Draft decision

Jemena Gas Networks (NSW) Ltd

Access arrangement 2015–20

Attachment 6: Capital expenditure

Figure 6-3 JGN's proposed total planning costs (\$million, real 2014-15)

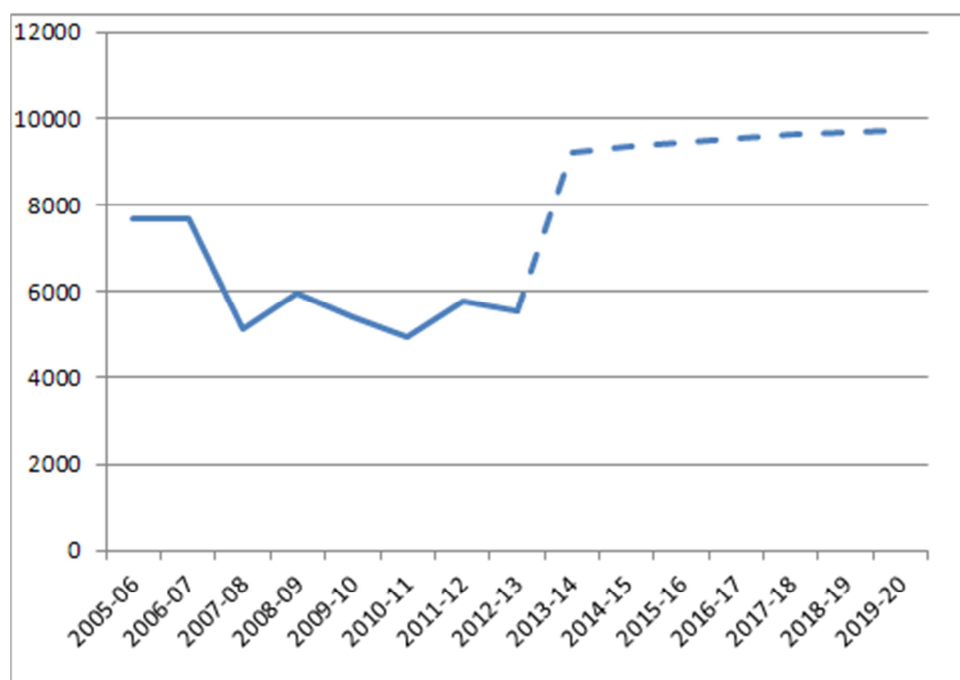
We are not satisfied that JGN has justified its proposal to increase planning costs. In assessing the total proposed planning costs, that is, the amounts included in overheads plus the amounts proposed to be included in the facilities renewal and upgrade category, we considered the forecast trend in expenditure against the historical trend (see Figure 6-3). Planning costs have been relatively stable over the 2007-13 period. JGN have forecast a 66 per cent step increase in planning costs. We consider that there are only incremental changes in the size and complexity of the JGN network. We have no evidence available to us that suggests that there are any changes in obligations which would impact planning requirements. For these reasons we have not included the step increase in forecast planning costs, which JGN proposed to include in the facilities renewal and upgrade category.
